CRUSCENT AVENUE
84-H-15 PLAKS ISLAND

PERMIT # **001272**

October 13, 1988

RE: Crescent Ave. Peaks Island, Maine 04108

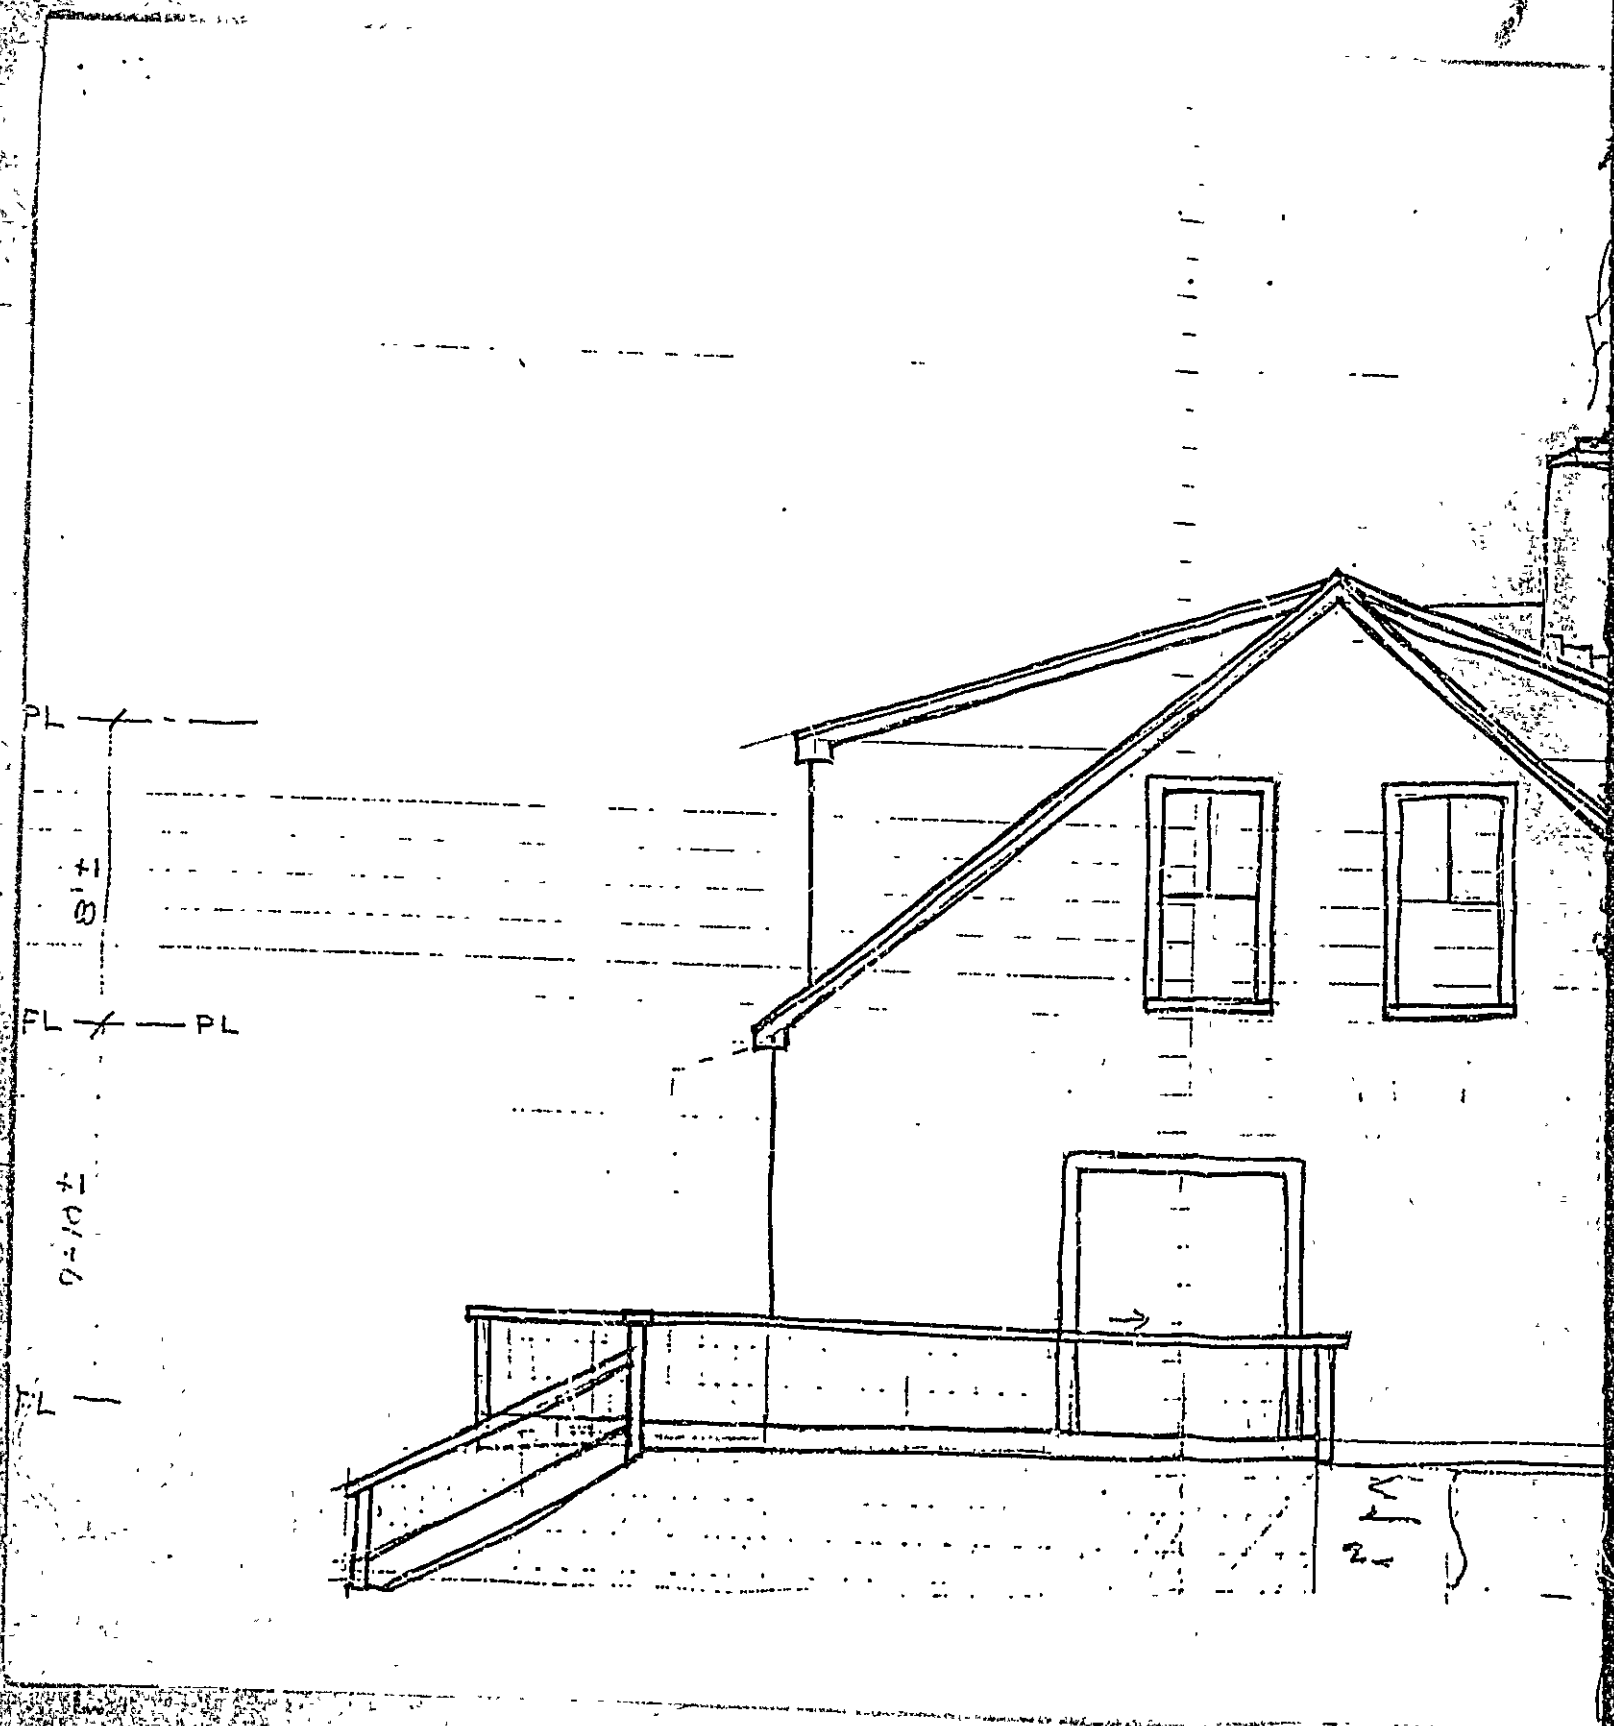
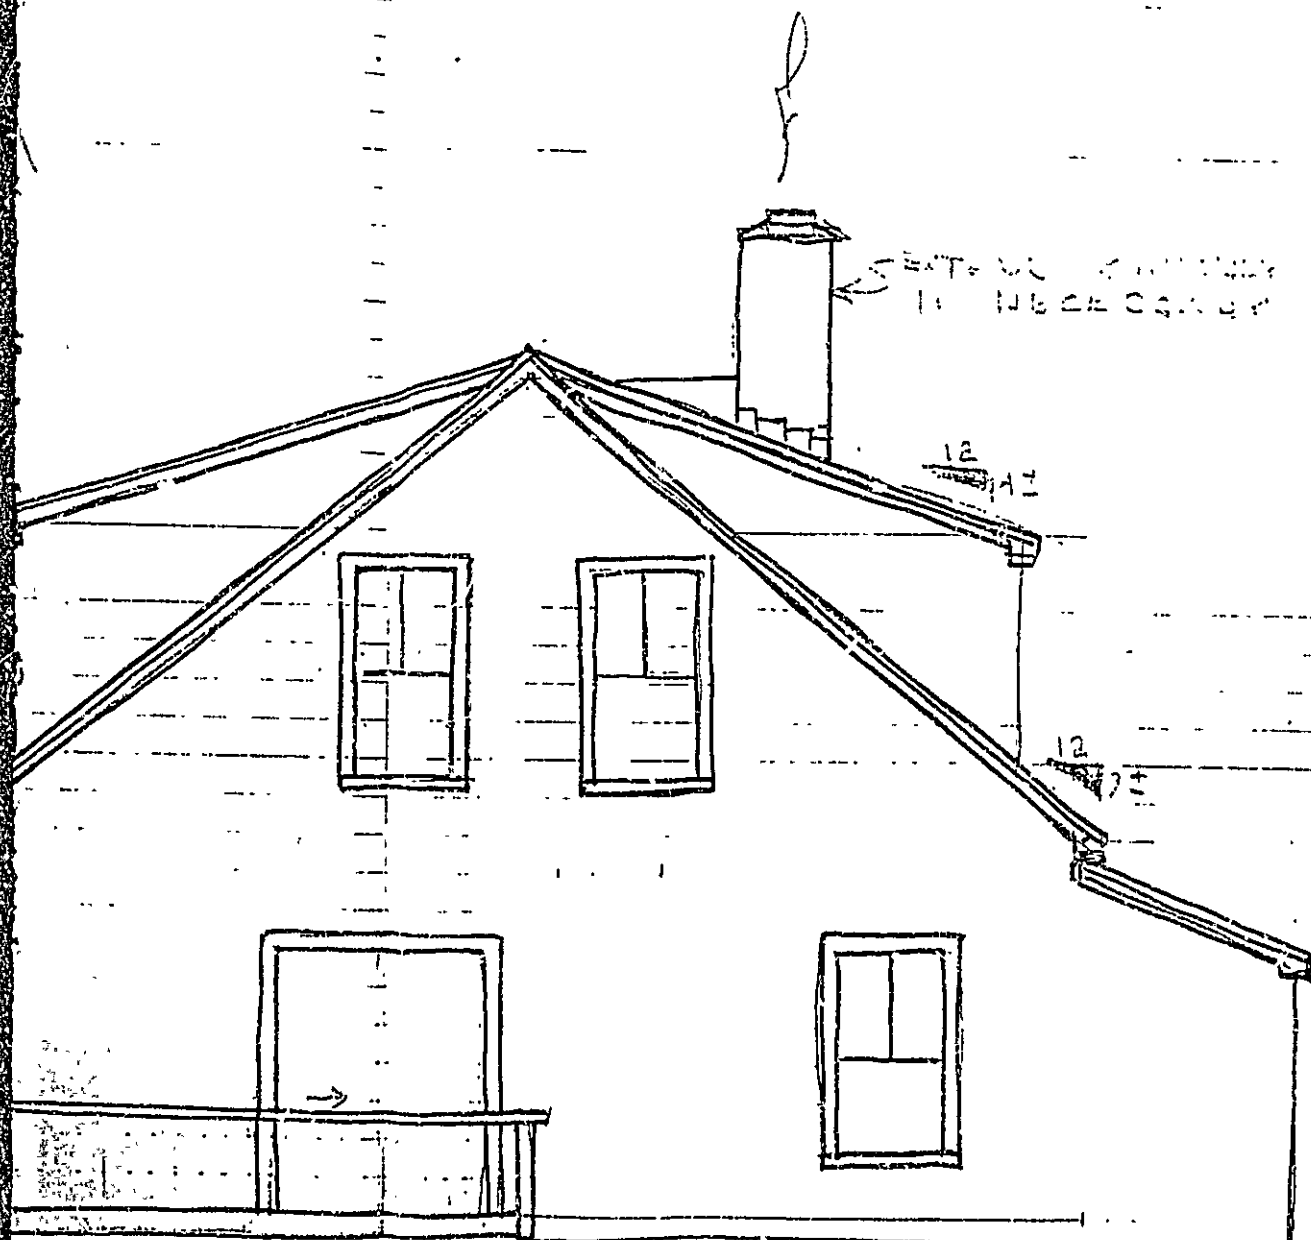
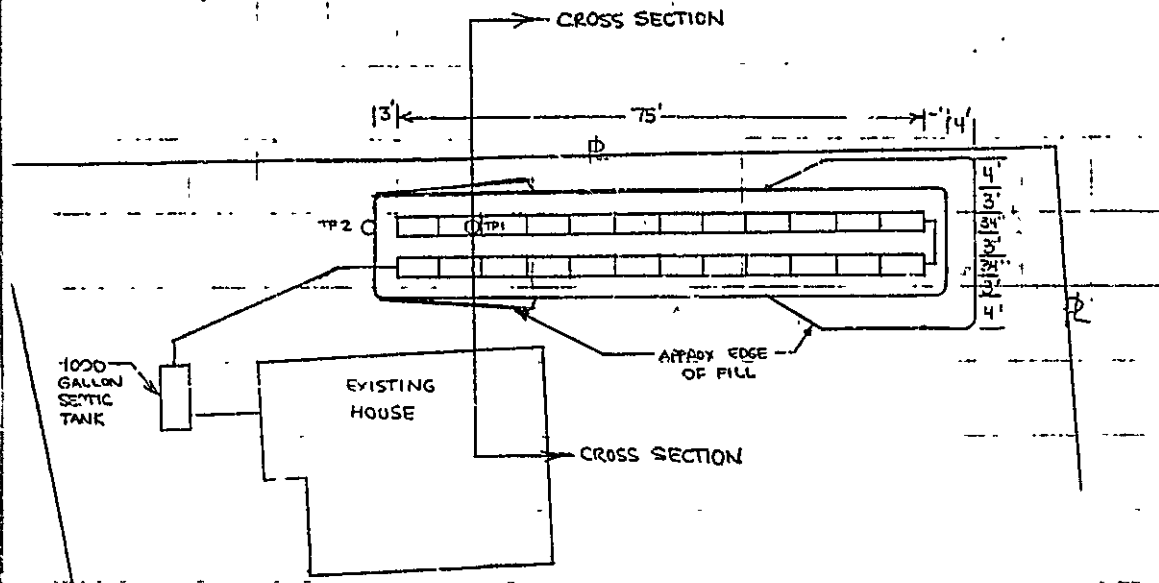
Your application to construct 2 full domers has been reviewed and a permit is herewith issued subject to the following requirements:

- 1.) Your plan doesn't show any framing detail, therefore this permit is being issued with the understanding that a minimum of 2"X8" 16 O.C. will be used for rafters.
- 2.) With 2"X4"X16 O.C. stud walls.
- 3.) Headers size minimum 2-2"X4" on edge.
